RECEIVED  
05/03/2022  
CITY OF MONROE

# Riverside Station Apartments

## Drainage Report

20 July 2022. No corrections or revisions requested, however see comment on page 9 of this PDF and sheet 7 of the preliminary site plan civils. There may be changes regarding overflow provisions. T. Gathmann

FIGURE  
A-6

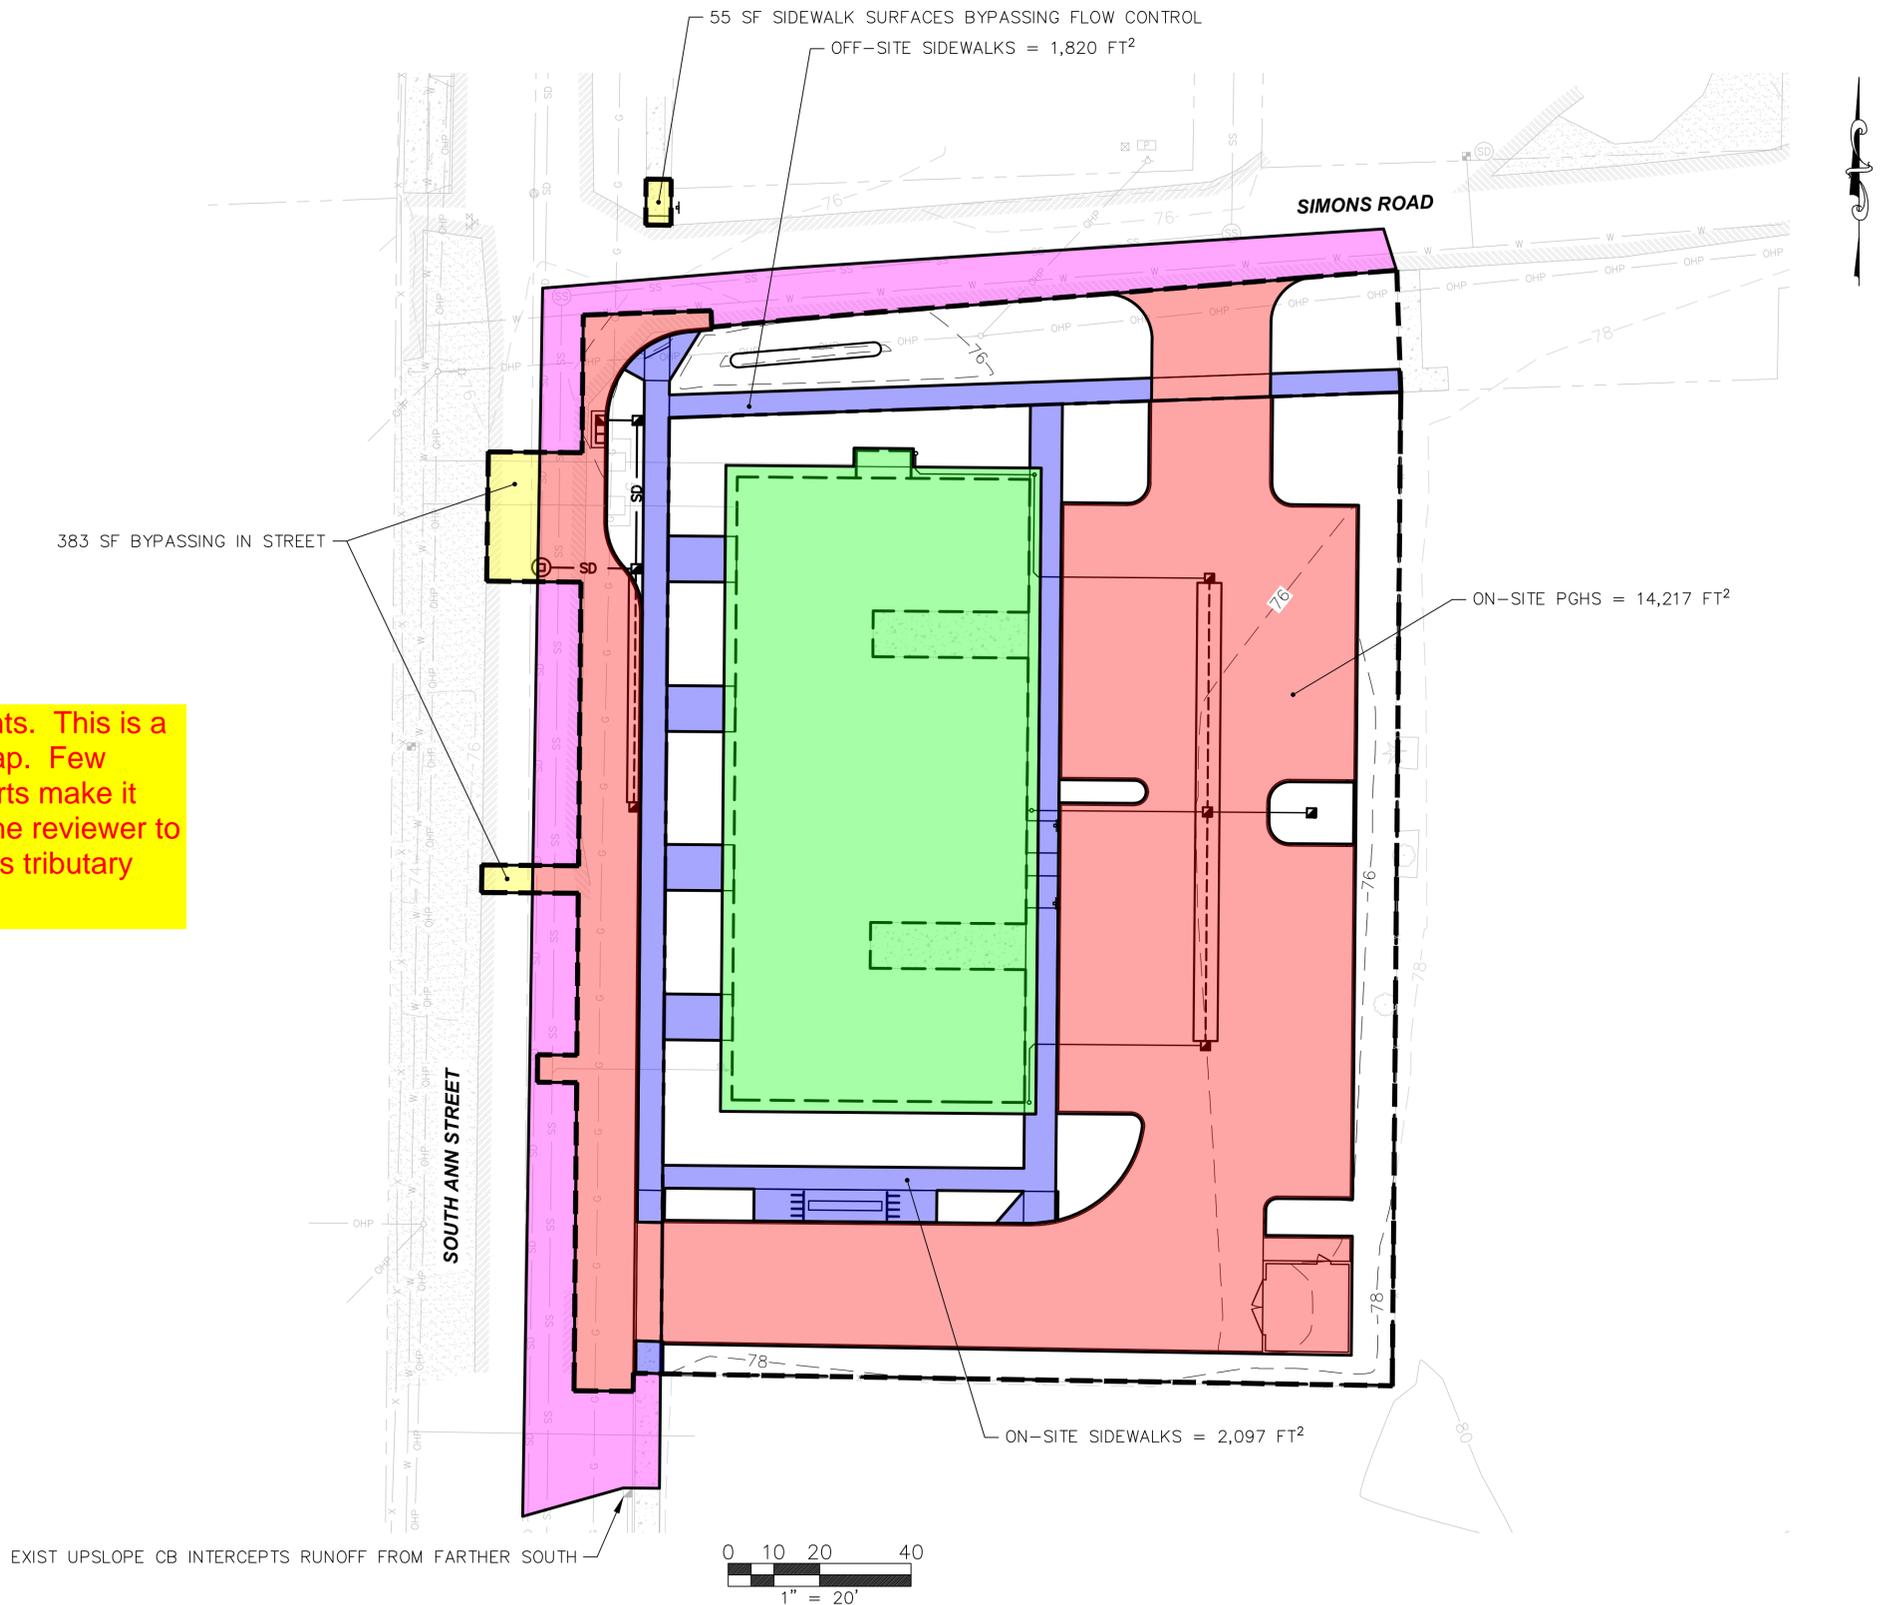
**My compliments. This is a very useful map. Few drainage reports make it this easy for the reviewer to see the various tributary areas.**
